Access Compliance Report

Public Rights-of-Way

Intersection ID: 12425	Main Street: W_MOREHEAD_ST	Cross Street: ELDRIDGE_ST	Location: E
ADA ID: D9B5CDDACC8F	Ramp Type: PerpDiag	Initial Pass/Fail: Fail	Overall Compliance: No
Severity Score: 13.75			
Codes/Mitigation Info/Possible Solution		Field Measurements/Component Compliance

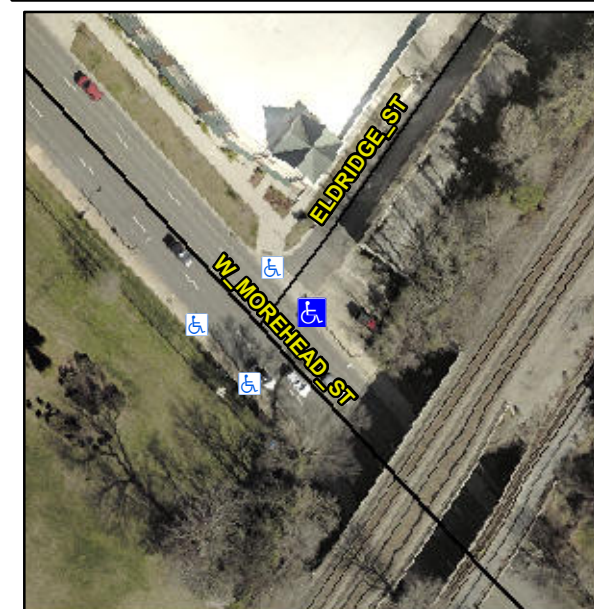
Not Found, R304.2.2, R304.5.3

Compliance	Description	Data	Compliance	Description	Data
N/A	Ramp Length (in)	33.0	No	Ramp Slope (%)	10.6
Yes	Ramp Width (in)	48.0	No	Ramp XSlope (%)	4.0
N/A	Flare Type LT	N/A	N/A	Flare Type RT	N/A
N/A	Flare Slope LT (%)	N/A	N/A	Flare Slope RT (%)	N/A
N/A	Flare Traversable LT?	N/A	N/A	Flare Traversable RT?	N/A
N/A	Landing Length (in)	N/A	N/A	DWS Provided?	N/A
N/A	Landing Width (in)	N/A	N/A	DWS Contrast?	N/A
N/A	Landing Slope (%)	N/A	N/A	DWS Length (in)	N/A
N/A	Landing X Slope (%)	N/A	N/A	DWS Full Width?	N/A
N/A	Landing Curb? (Y/N)	N/A	N/A	DWS Offset (in)	N/A
N/A	Shared Landing?	N/A			
N/A	Gutter Ponding?	N/A	N/A	Gutter Slope (%)	N/A
N/A	Gutter Lip Ht (in)	N/A	N/A	Gutter X Slope (%)	N/A
N/A	Painted X Walk1?	No	N/A	Painted X Walk2?	No
	X Walk 1 Direction	To NW		X Walk 2 Direction	To SW
N/A	X Walk 1 Width (in)	N/A	N/A	X Walk 2 Width (in)	N/A
	X Walk 1 Slope (%)	1.6		X Walk 2 Slope (%)	2.8
	X Walk 1 X Slope (%)	3.3		X Walk 2 X Slope (%)	1.8

N/A	Ramp inside XWalk1?	N/A	N/A	Ramp inside XWalk2?	N/A
	Road Slope (%)	4.5	N/A	Clear Space?	N/A
	Road X Slope (%)	4.5	N/A	Clear Space to XWalk (in)	N/A
N/A	Any Obstructions?	N/A	N/A	Storm Grate/Utility Hazard?	N/A
	Obstruction Type			Storm Grate/Utility Type	
		N/A			N/A
		Yes		Surface Condition? (G/P)	Good

Remove & Replace Curb Ramp With Two New Directional Ramps or Equivalent.
